Access Compliance Report

Public Rights-of-Way

(Curb Ramps)

Intersection ID: 43659	Main Street: TAYLOR RIDGE LN	Cross Street: STARR NEELY RD	Location: SE
ADA ID: 4573BB8EC181	Ramp Type: PerpDiag	Initial Pass/Fail: Pass	Overall Compliance: No
Severity Score: 25.25			
Codes/Mitigation Info/Possible Solution		Field Measurements/Component Compliance

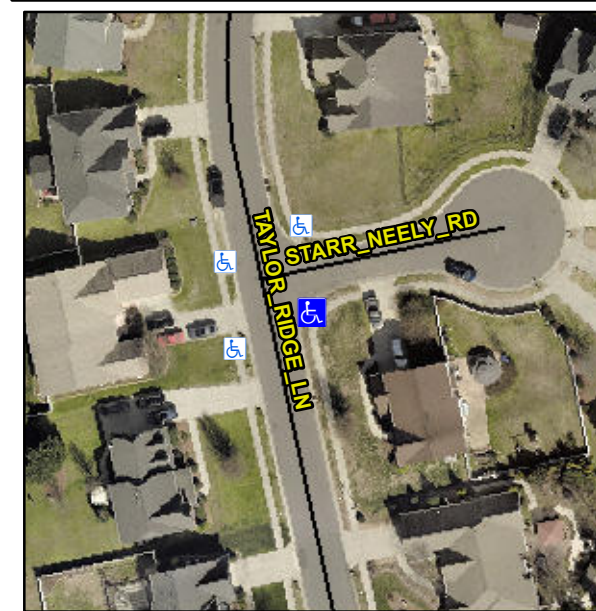
Not Found, R304.5.3, R304.2.2-Perp, R304.3.2-Para, R305, R302.7.2

Compliance	Description	Data	Compliance	Description	Data
N/A	Ramp Length (in)	47.0	Yes	Ramp Slope (%)	6.6
Yes	Ramp Width (in)	82.0	No	Ramp XSlope (%)	3.6
N/A	Flare Type LT	None	N/A	Flare Type RT	N/A
N/A	Flare Slope LT (%)	N/A	N/A	Flare Slope RT (%)	N/A
N/A	Flare Traversable LT?	N/A	N/A	Flare Traversable RT?	N/A
Yes	Landing Length (in)	48.0	No	DWS Provided?	No
Yes	Landing Width (in)	79.0	N/A	DWS Contrast?	No
No	Landing Slope (%)	3.8	N/A	DWS Length (in)	N/A
Yes	Landing X Slope (%)	1.9	N/A	DWS Full Width?	No
N/A	Landing Curb? (Y/N)	No	N/A	DWS Offset (in)	N/A
N/A	Shared Landing?	No			
Yes	Gutter Ponding?	No	Yes	Gutter Slope (%)	4.3
No	Gutter Lip Ht (in)	1.5	No	Gutter X Slope (%)	3.2
N/A	Painted X Walk1?	No	N/A	Painted X Walk2?	No
	X Walk 1 Direction	To N		X Walk 2 Direction	To W
N/A	X Walk 1 Width (in)	N/A	N/A	X Walk 2 Width (in)	N/A
	X Walk 1 Slope (%)	1.3		X Walk 2 Slope (%)	2.3
	X Walk 1 X Slope (%)	0.4		X Walk 2 X Slope (%)	0.7

Remove & Replace Curb Ramp With Two New Directional Ramps or Equivalent. Remove & Replace Gutter.
